**REZONING,
PLANNED UNIT DEVELOPMENT
& SUBDIVISION STAFF REPORT**

<u>DEVELOPMENT NAME</u>	Pike Manor Ltd.
<u>SUBDIVISION NAME</u>	Lot A, Rangeline Park Subdivision, 6th Addition, Resubdivision of Lot 1, Phase I, and Lot 2, Phase II
<u>LOCATION</u>	Northeast corner of Rangeline Service Road and Abigail Drive
<u>CITY COUNCIL DISTRICT</u>	District 4
<u>PRESENT ZONING</u>	R-1, Single-Family Residential
<u>PROPOSED ZONING</u>	I-1, Light Industrial
<u>AREA OF PROPERTY</u>	1 lot/2.4± acres
<u>CONTEMPLATED USE</u>	<p>Subdivision Approval to combine two legal lots of record into one lot, Planned Unit Development Approval to allow three buildings on a single building site, and Rezoning from R-1, Single-Family Residential District, to I-1, Light Industry District, to bring the zoning into compliance for an equipment rental business.</p> <p>It should be noted, however, that any use permitted in the proposed district would be allowed at this location if the zoning is changed. Furthermore, the Planning Commission may consider zoning classifications other than that sought by the applicant for this property.</p>

APPLICATION NUMBER 7, 8, 9 DATE April 16, 2009

SITE PLAN

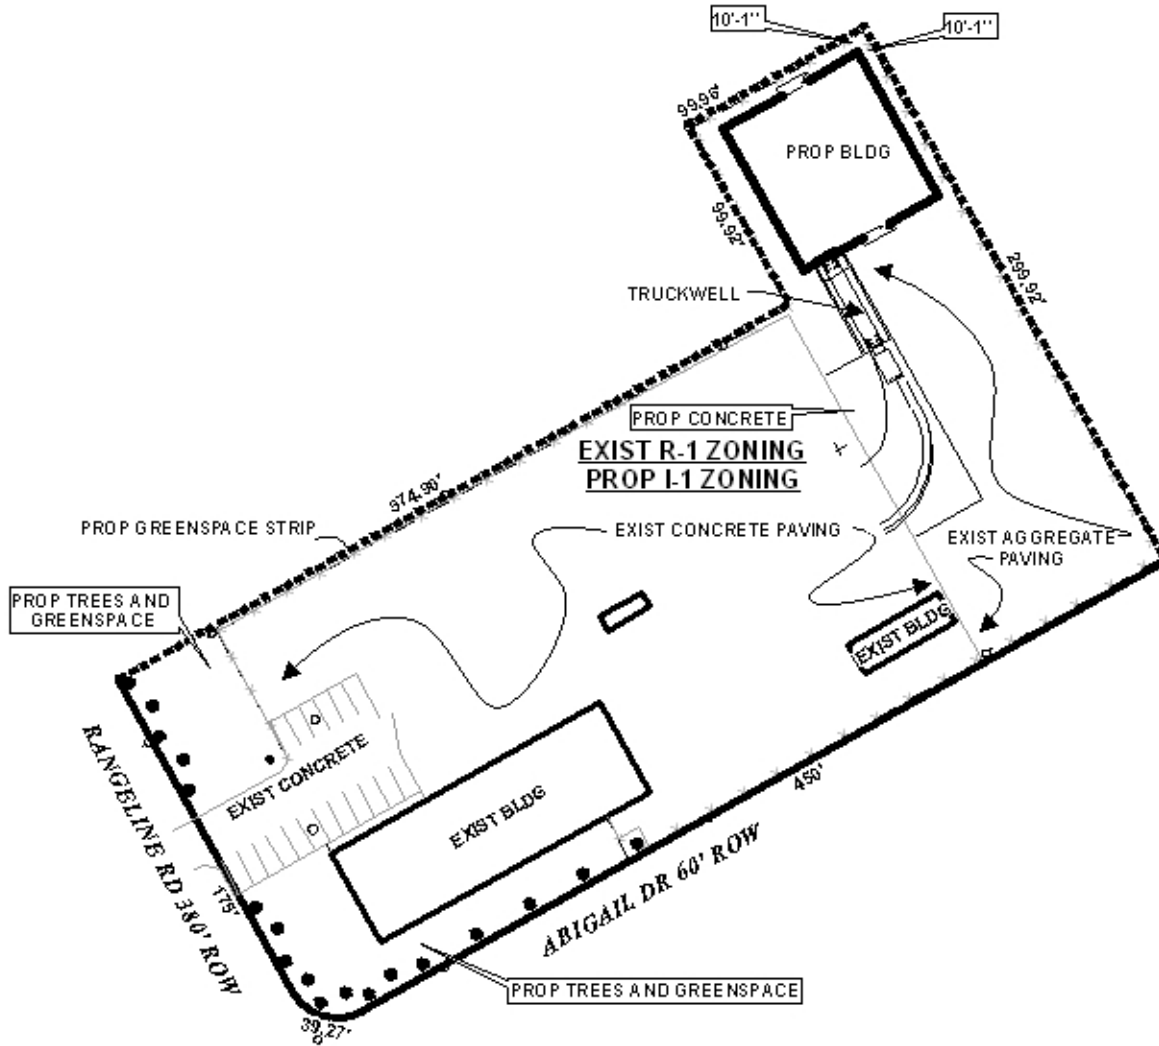
As illustrated on the site plan, the site has approximately 175' and 450' of frontage along Rangeline Road and Abigail Drive, respectively, with one existing curb cut to Rangeline Road. No access is depicted to Abigail Drive. Since the site is part of a Planned Unit Development, curb cuts will be limited to the approved PUD site plan.

The site plan illustrates three buildings: two existing (7580 and 813 sq ft) and one proposed (6000 sq ft). Of the 14,393 total square feet of building area, 2500 square feet is devoted to office space and the rest as warehousing (maximum 9 warehouse employees). The applicant is providing 18 parking spaces (only 12 are required).

The site plan also illustrates a 50' truck loading space with 90' of maneuvering area in front of the proposed warehouse in the rear of the site, compliant with Section 64-6.B of the Zoning Ordinance. The applicant is proposing some aggregate surfacing in the rear, which may be appropriate for the storage (lay-down) area.

There are no sidewalks illustrated on the site plan, which will be required prior to the issuance of any permits.

The applicant should revise the site plan to depict a dumpster (screened from view), in compliance with Section 64-4.D.9 of the Zoning Ordinance, or provide a note on the site plan stating that no dumpster will be provided. The applicant should also provide a 25' minimum building setback line along both Rangeline Road and Abigail Drive.

- 5) revision of the site plan to illustrate a dumpster (screened from view), in compliance with Section 64-4.D.9 of the Zoning Ordinance, or the provision a note on the site plan stating that no dumpster will be provided;

- 6) provision of a 25' minimum building setback line along both Rangeline Road and Abigail Drive;
- 7) placement of a note on the site plan stating that the approval of all applicable federal, state and local environmental agencies is required prior to the issuance of any permits or land disturbance activities;
